2020 Corvette: Service Bulletin: #N202302840: Service Update - Door Paint Chipping

Subject: N202302840 — Door

Paint Chipping

Models: 2020 Chevrolet Corvette

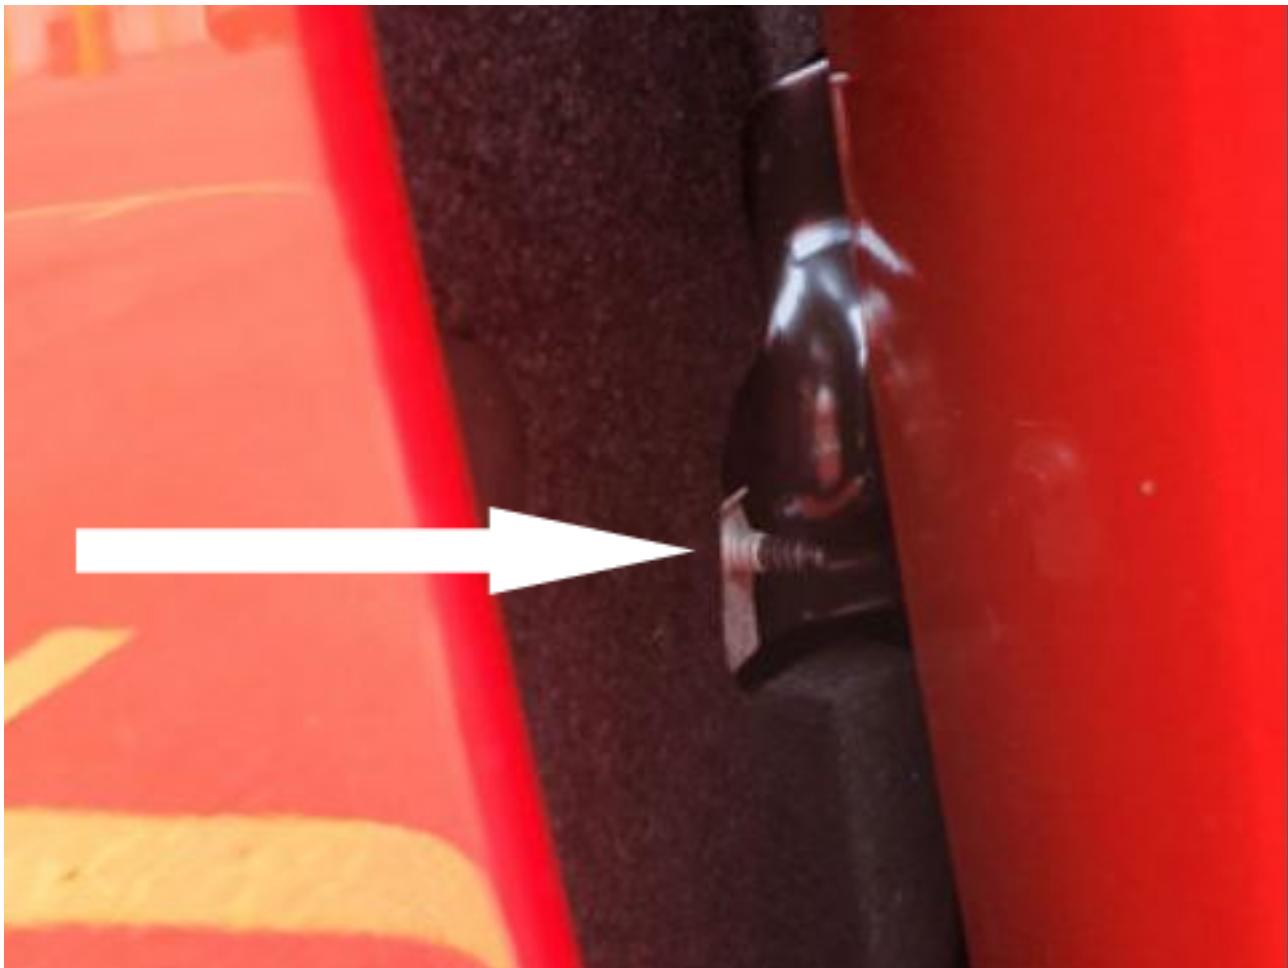
1. Carefully open the left front door inspecting for any contact with the fender fastener. This fastener is located just below the door check strap area.
2. Locate the threaded portion of the fender mounting bolt where

it exits the nut.

3. Count the number of threads showing.

- If less than 1 full thread is showing, no further action is required.

- If more than 2 threads are showing, proceed to step # 4.
- Partially remove the wheelhouse liner to access the rear fender mounting fasteners. Refer to *Front Wheelhouse Liner Replacement* in SI.

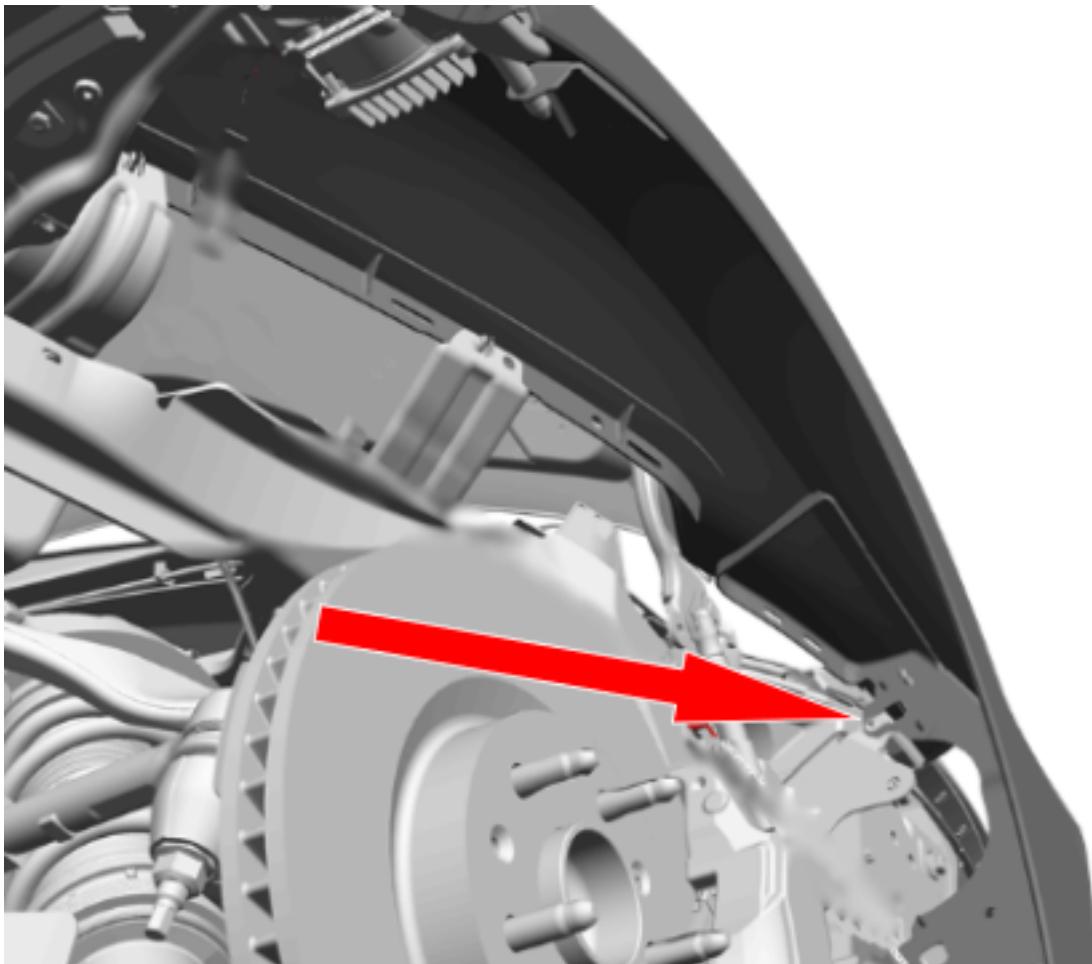
1. Locate and remove the center fender to body fastener as shown.
2. Install the shorter service fastener. Tighten 9 Nm (80 lb in).
3. Reinstall the wheelhouse liner. Refer to *Front Wheelhouse Liner Replacement* in SI.
4. Repeat steps 1-7 on the right side of the vehicle.
